Addendum / Addenda

Project Description / Description de projet		
M58 Abatement Ground Floor South		
Solicitation No./N° de sollicitation	Project No./N° de projet	W.O. No./N° d'ordre de travail
15-22093	5083	A1-006947-04-01
Departmental Representative / représentant ministériel		Date
Mark O'Connor		October 7, 2015
Notice:		Nota:
This addendum shall form part of the tender documents and all conditions shall apply and be read in conjunction with the original plans and specifications.		Cet addenda fait partie intégrale des dossiers d'appel; toutes les conditions énoncées doivent être lues et appliquées en conjonction avec les plans et les devis originaux.

project **M-58 HAZARDOUS MATERIAL ABATEMENT** projet
GROUND FLOOR, SOUTH WING

drawing **SCALE PLAN FOR ADDENDUM #1** dessin
 WHEN PRINTED TO SIZE INDICATED AT
 BOTTOM LEFT OF DRAWING

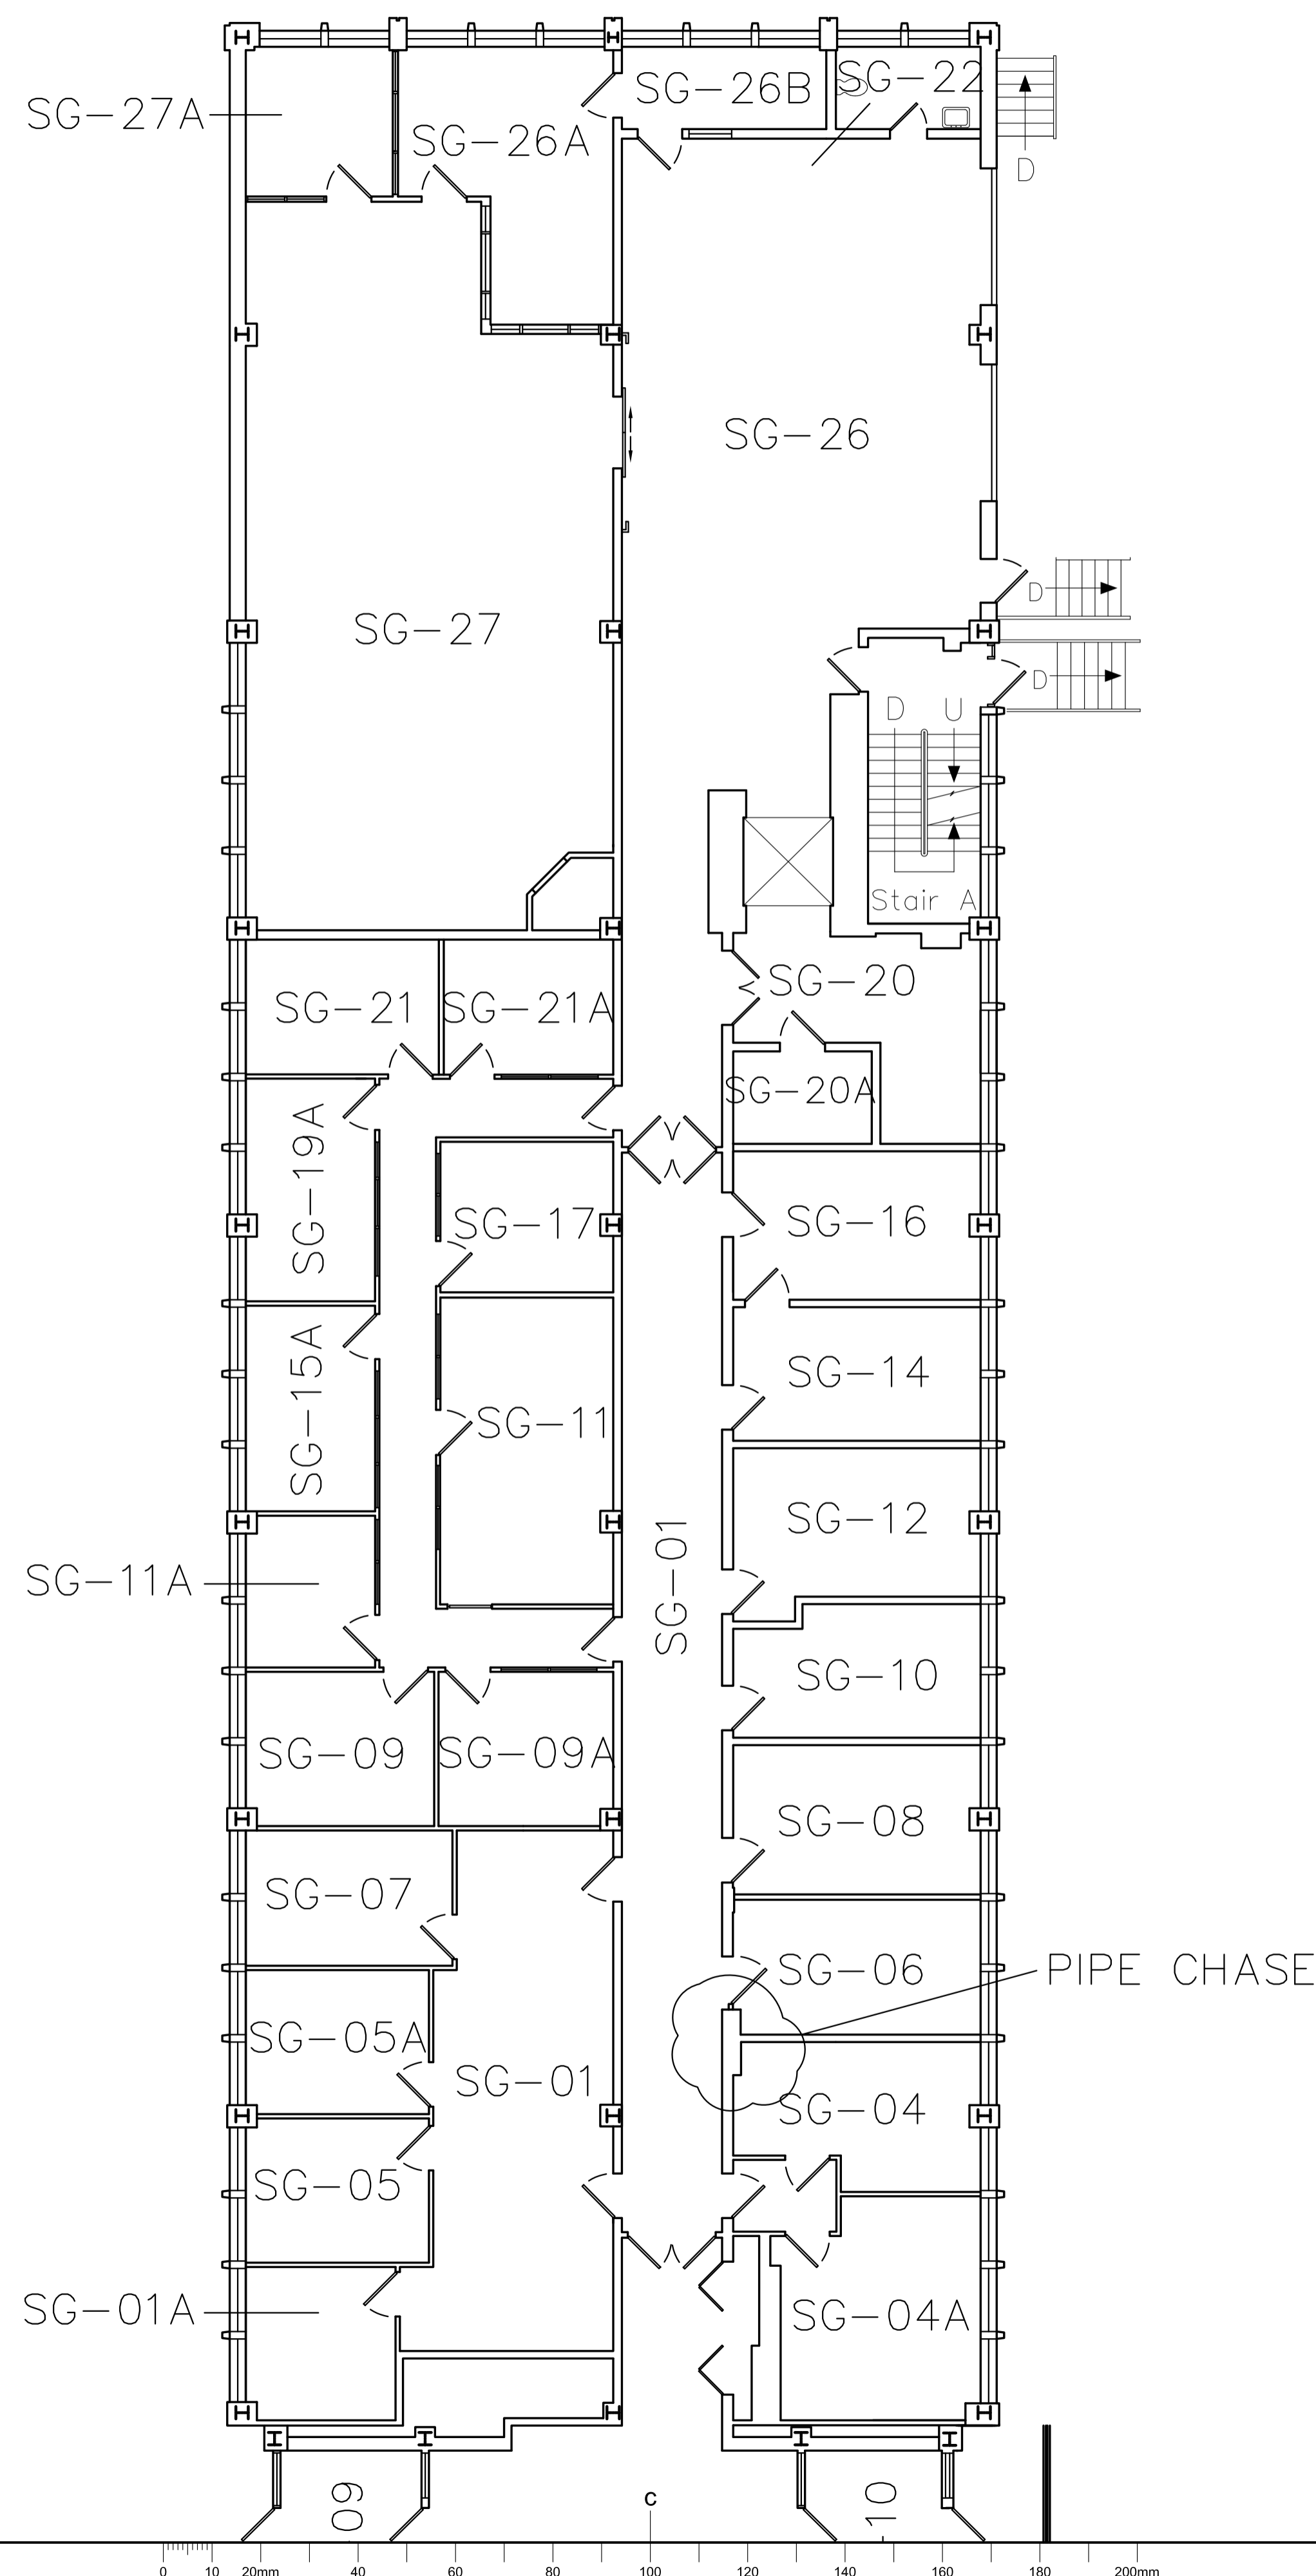
- 1 Steel drawings attached for reference. Drawing #S21
- 2 Scale architectural drawing attached for reference. Dated Oct 6 2015. Pipe chase noted on drawing that contractor must open to allow for abatement.

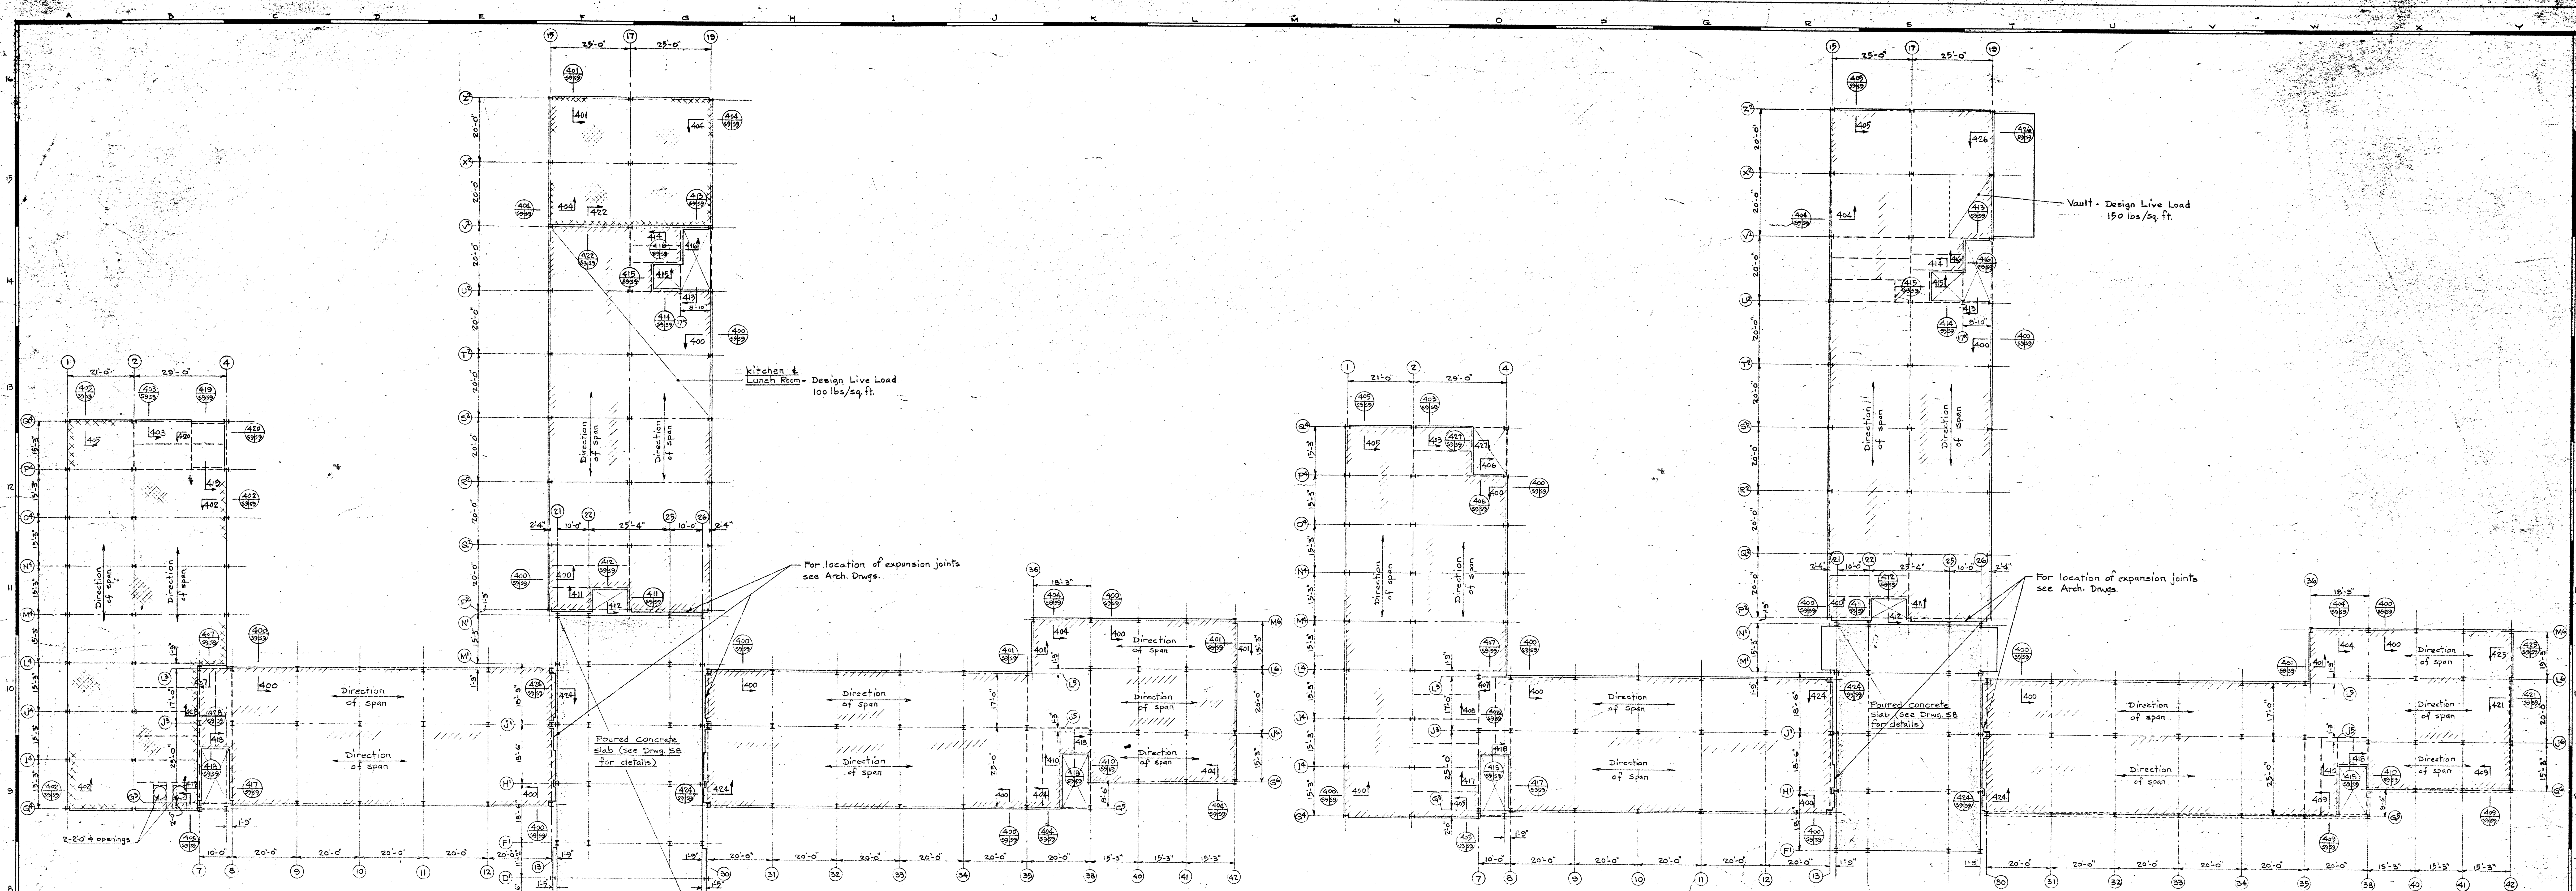
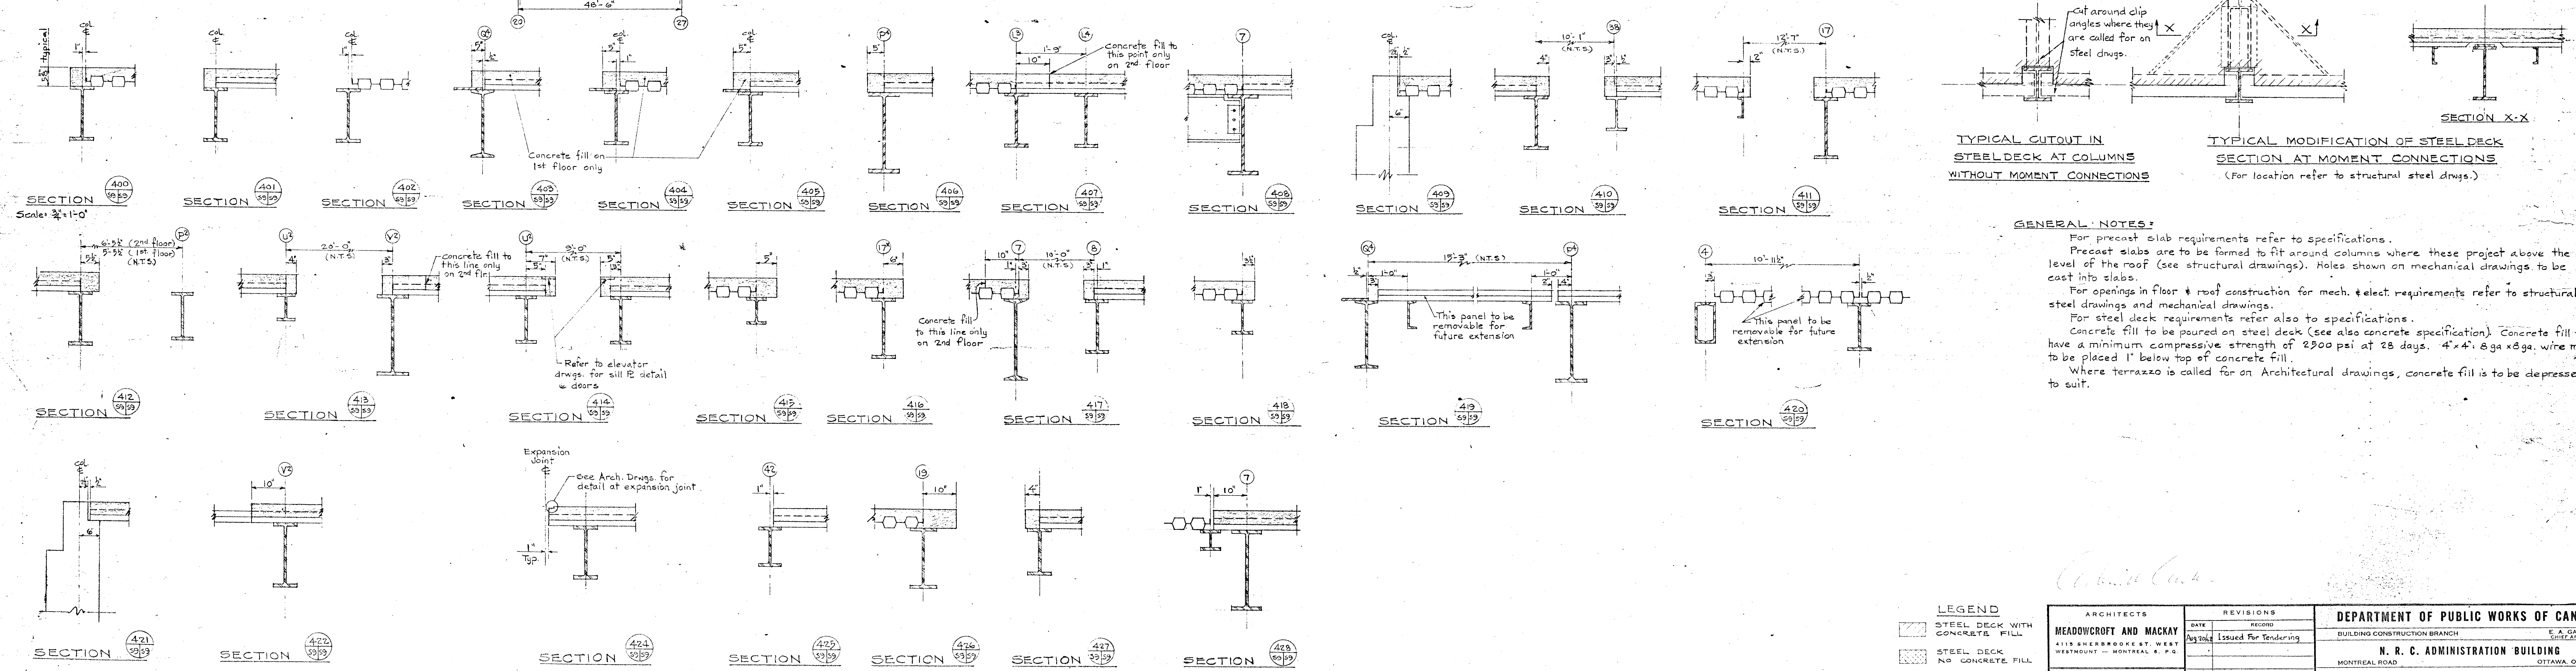
- 6 Window blinds to be removed and disposed of by contractor.
- 7 Clarification: Existing concrete ceiling is poured on a corrugated steel deck. Drawing #S9 Floor and Roof Construction attached for reference.
